Design Review Committee

March 13, 2024 – REGULAR MEETING

Town of Jackson Design Guidelines Checklist

Item Number: P24-014

FLOOR PLAN - LEVEL 1

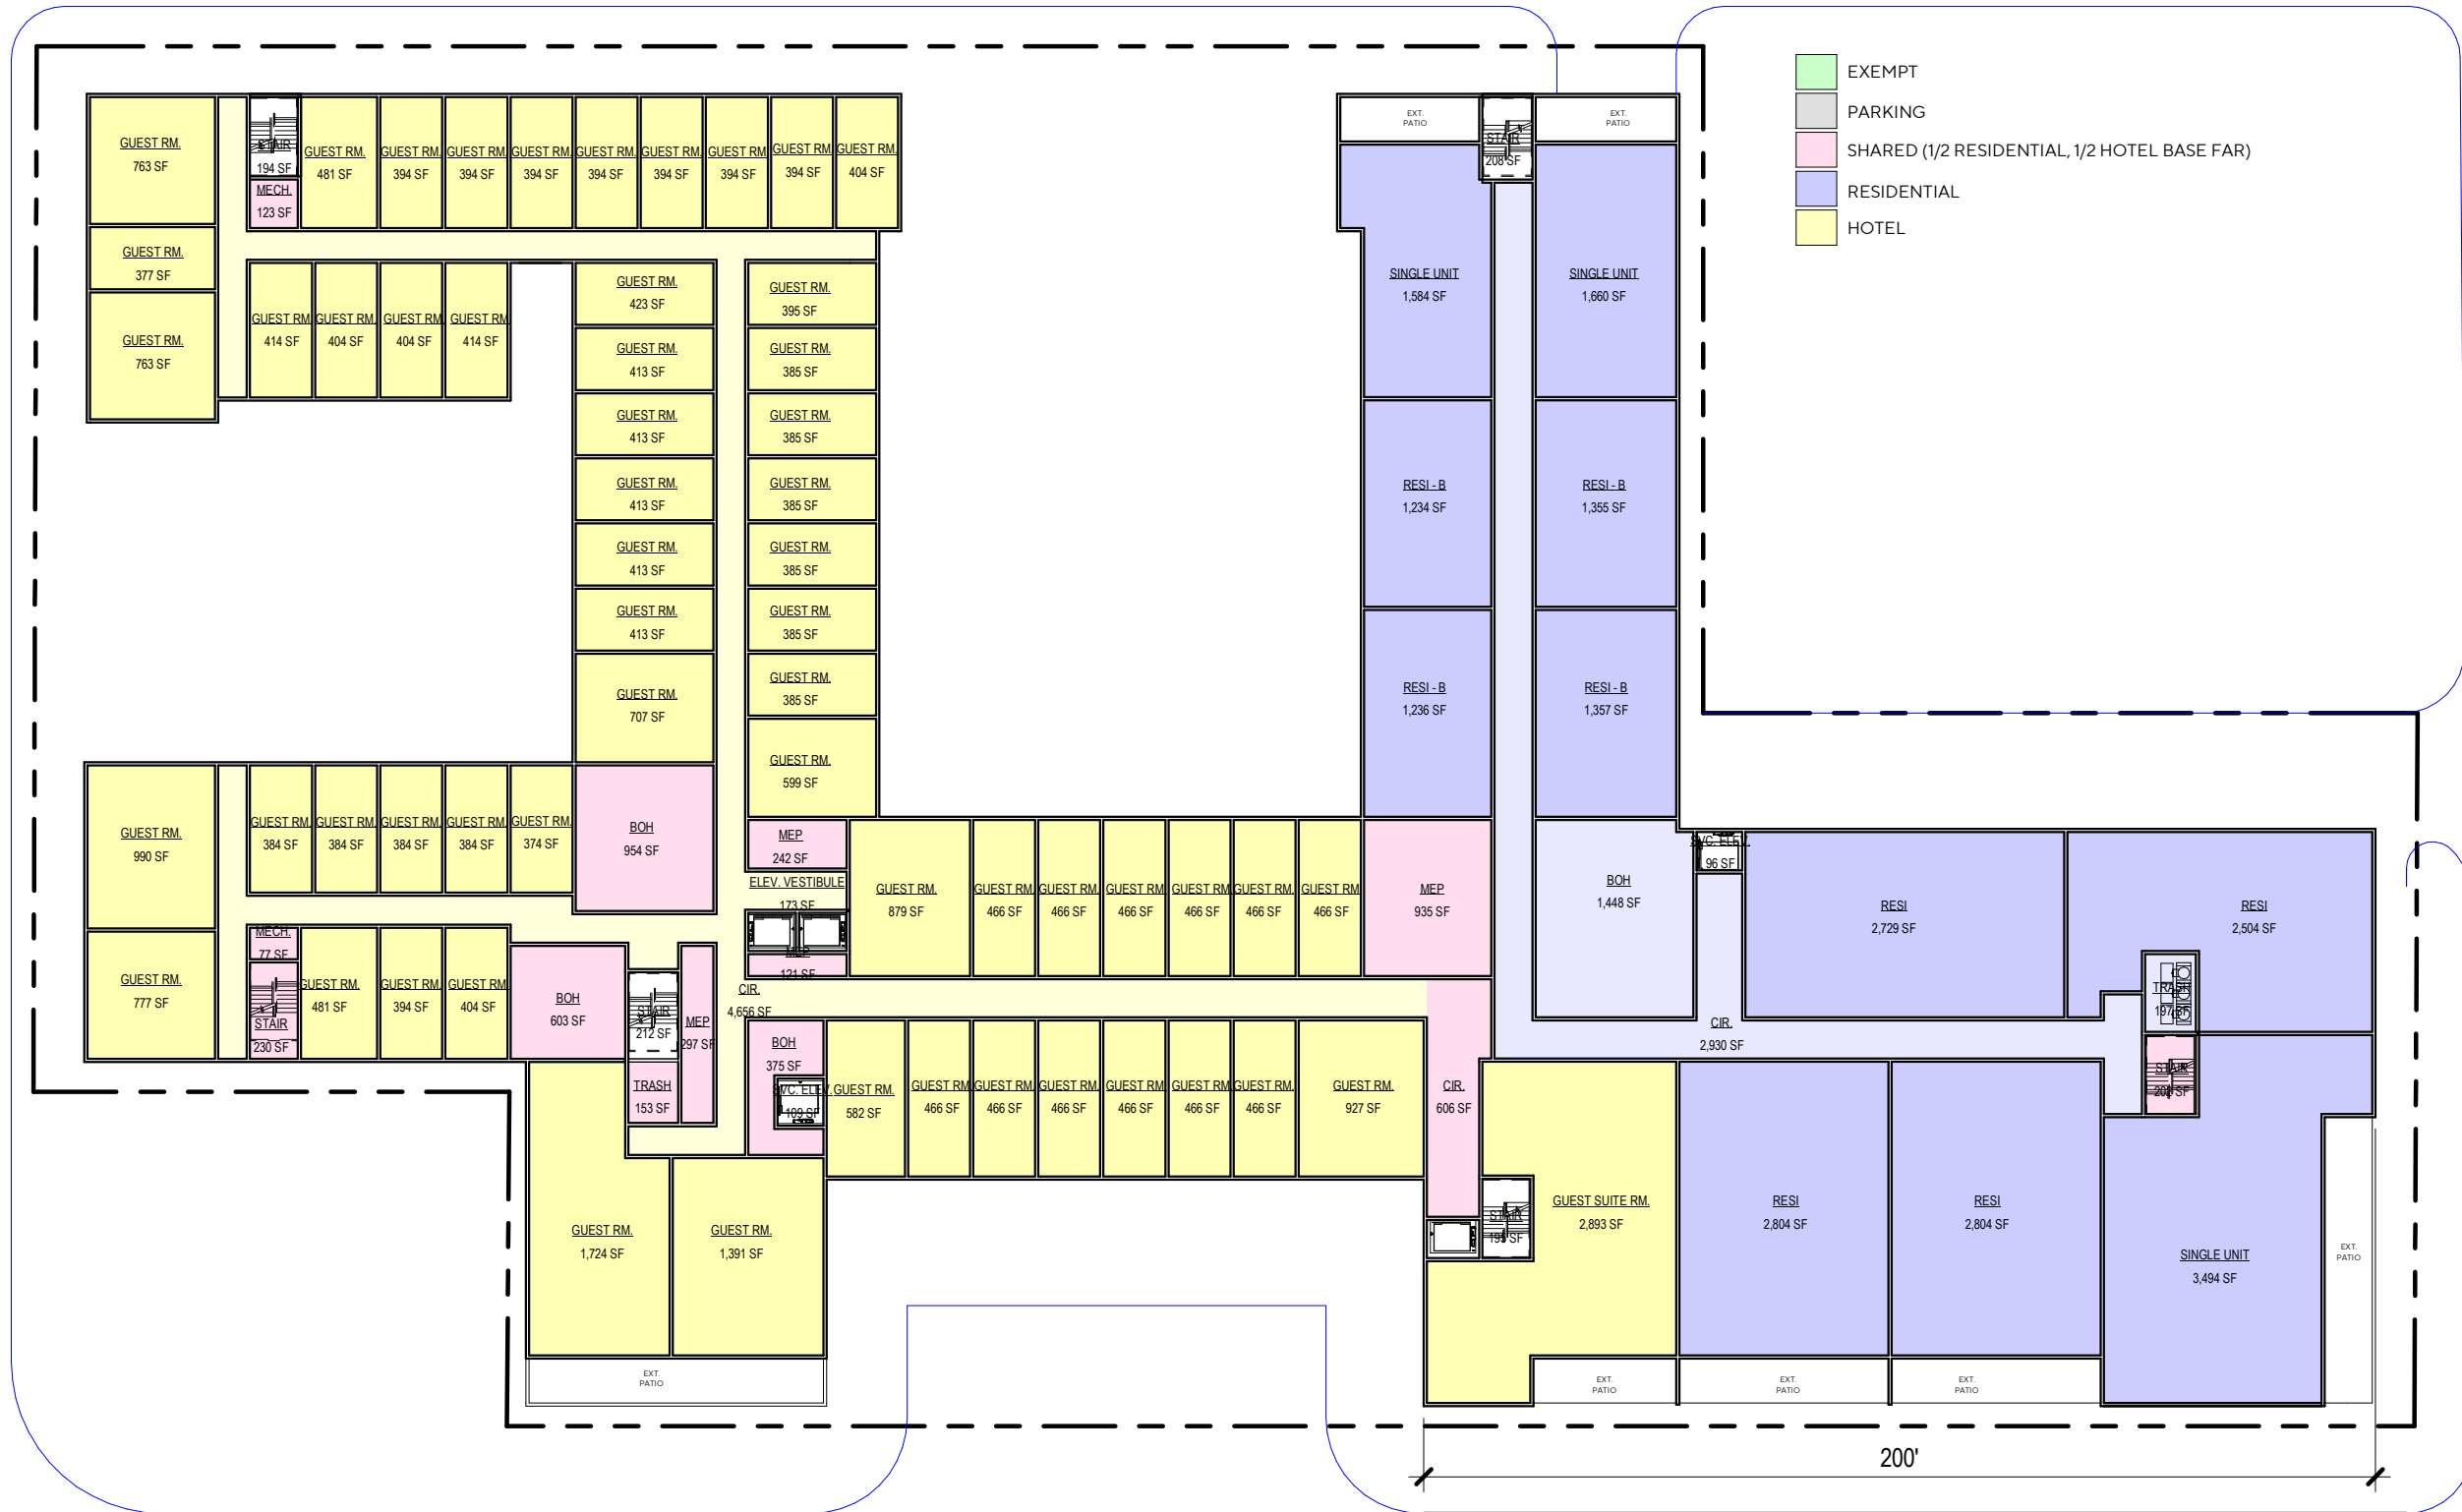
- **ENTRANCE:** The entrance off of Cache is too pronounced in its size and what it serves, which is mostly serving the automobile. This portion of the project needs to be further studied and modified to better enhance the pedestrian experience and street wall appearance. DRC felt that the entrance as proposed conflicts with several goals of the Design Guidelines, and the applicant needs to address the specific guidelines below both in writing and in the revised renderings:

3. CURB CUTS: The curb cuts along Cache appear to be wider than the maximum 24' per curb cut. Need to verify with the applicant.
4. ROOFTOP STAIRS: The BOH area associated with the rooftop bar does not benefit from additional height and needs to be removed.

7. SNOW STORAGE: Snow storage has not yet been confirmed.
8. PLANT UNITS: Plant units have not yet been shown.
9. BASEMENT PATIOS: basement patios cannot encroach into the 13.5' pedestrian frontage.

- **Applicant response to the DRC Comment 1:**
 - *In response to the DRC feedback regarding the entrance, the Applicant revised the entrance to reduce the scale and pronunciation. The entrance off of North Cache was reduced in size substantially, and no longer slopes upward to bring the entrance above the basement level. The entrance was redesigned to be at the existing grade level of North Cache. In addition, the Applicant has introduced new vegetation including trees, bushes, and other planted landscaping to provide a buffer to the entrance.*

- Adjusted retail spaces along the edge of the paseo to activate the space
- **L1**
 - Adjusted porte cochere to reduce width, depth and scale
 - Added pedestrian canopy to Porte Cochere/entrance off N Cache

- Relocated loading to end of alley
 - Added retail at side of Porte cochere to activate the arrival experience.
 - Enclosed patio at café
 - Moved ball room and replaced with guest rooms facing the courtyard

CACHE STREET FACADE ELEVATION

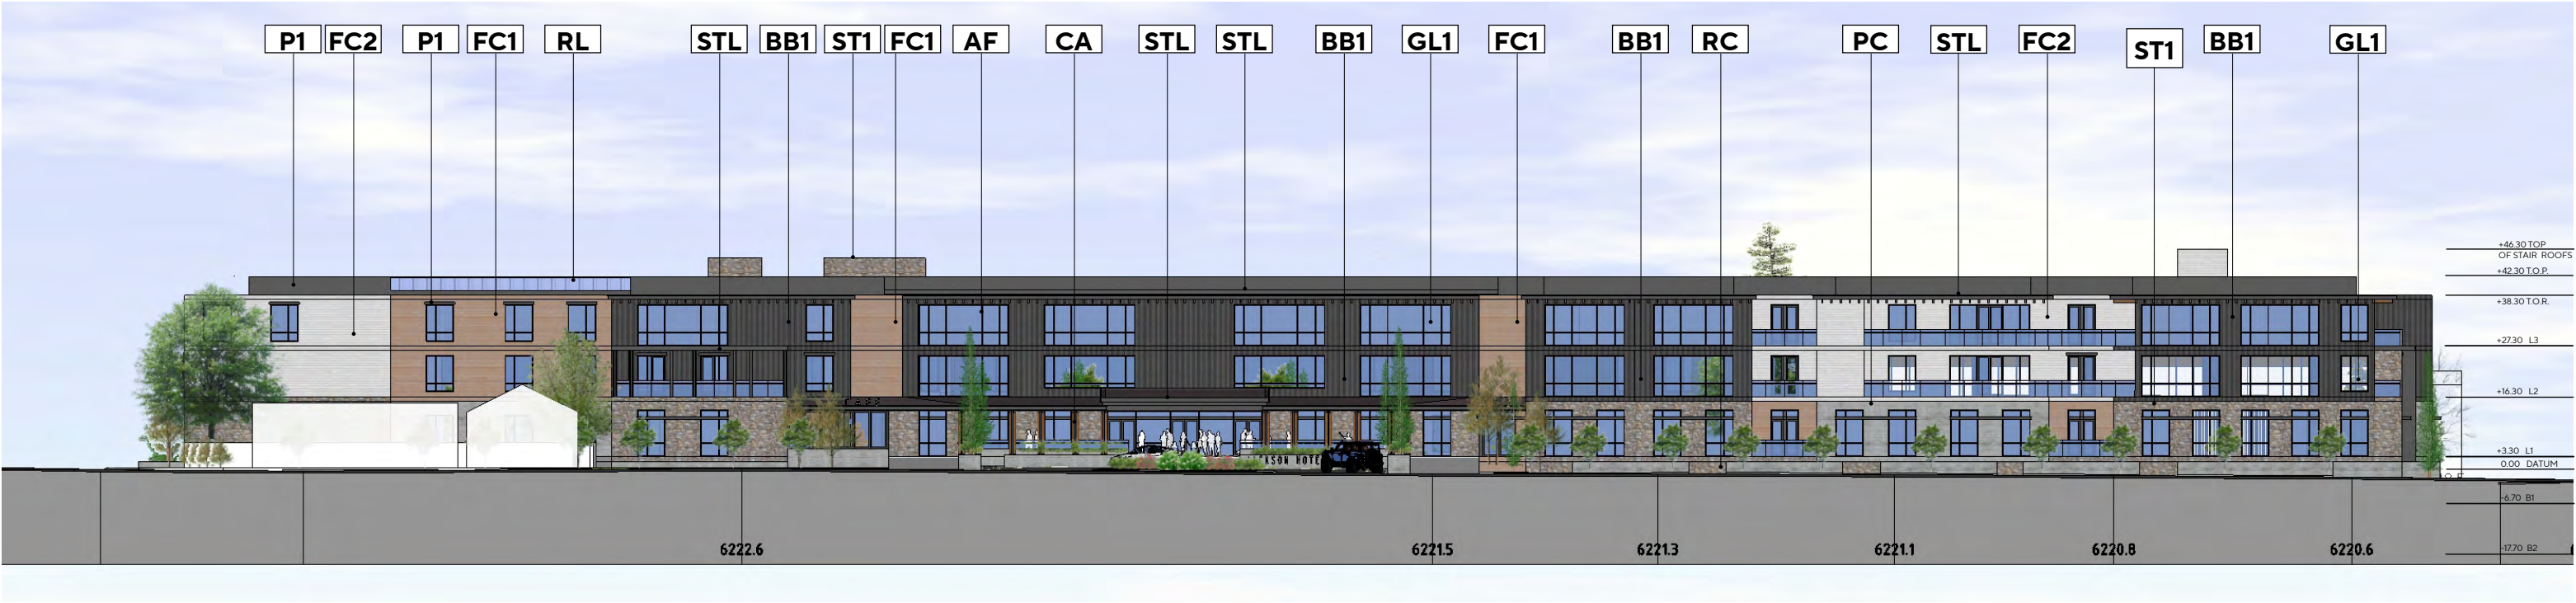
- **DRC Comment 2:**
 - **MASSING/SCALE:** Overall, the DRC agreed that the big massing moves to break up the bulk & scale of the building were successful. However, the applicant needs to further study the massing, especially how it relates to the application of materials. The DRC felt that the Cache elevation needs more horizontal and vertical moves to bring interest to this long frontage and enhance how this elevation, and the others, engages with the public/pedestrian realm. DRC felt that the massing as proposed conflicts with several goals of the Design Guidelines, and the applicant needs to address the specific guidelines below both in writing and in the revised renderings:

- **DRC Comment 5:**
 - **PEDESTRIAN EXPERIENCE:** The DRC directed the applicant to further study the pedestrian experience and how building and landscaping enhance the experience, especially along the Cache frontage. There are various guidelines above that reference the pedestrian experience and the applicant needs to address those on each side of the building. One suggestion was to show how landscaping is used to soften the building from the street. In addition, the applicant needs to show the

- **Applicant Response to DRC Comment #2:**
 - *As the DRC is aware, the incorporation of a portion of the alleyway allows a significant portion of the building massing to be located on the interior area of the project. This allows for the creation of multiple courtyards and an entrance off North Cache, all of which break up the massing and continuous street wall for the Project. In addition to the courtyard and entrance, the applicant has programmed and designed several balconies which provide further setbacks and breaks in the building massing. These mentioned features provide both vertical and horizontal breaks in the building massing.*

- *In response to the DRC feedback, Applicant made several changes to the project. The North Cache Street frontage and entrance were significantly adjusted following the committee's feedback. With those adjustments, additional landscaping was implemented for the North Cache Street frontage to a) improve the pedestrian experience while walking along the sidewalk, b) improve the pedestrian experience when approaching the hotel entrance. This was done by providing two additional pedestrian entrances that slope upwards from the sidewalk towards the building.*
